## Docket No. 272 - Development and Management Plan Inspection

## **Segment 4b Underground Line**

Date: November 15, 2006

Inspector: Lennox Keen

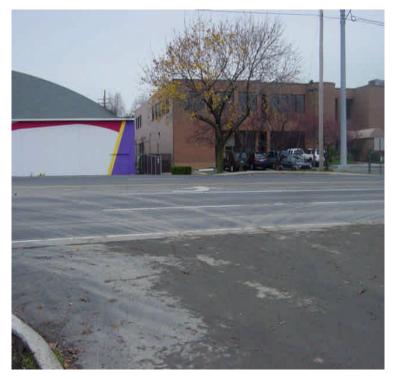
Areas of Inspection	Observation	Recommended Action	Corrected Action
Access Roads and Adjacent Roadways	All work is within or adjacent to existing paved roadways at this time.	See erosion control section.	NA
Vault Openings and Trench Construction Westport	Trenching activities continue on Rt. 1 from Buckley Ave. to Westfair Dr. 11/15/06	See erosion control section. 11/15/06	Most catch basins are protected (proactively).
	Trenching activities continue from Cedar Rd. to east of Wakenor Rd. 11/15/06	None. 11/15/06	Catch basins are protected (proactively).
Erosion and Sediment Controls Westport	Filter fabric or filter socks are installed in catch basins adjacent to most of the construction activities. 11/15/06	Continue place a gutter buddy (or similar) in any catch basins with a curb/gutter drop inlet to prevent sediment from entering basin. 11/15/06	Catch basins were protected.(Proactively)
	Catch basin located downgradient of construction activities at the intersection of Rt. 1 and Buckley Ave. is unprotected. 11/15/06	Protect catch basin from sediment. 11/15/06	Needs attention.

Photograph of an unprotected catch located downgradient of construction activities on Rt. 1 at the intersection with Buckley Ave.
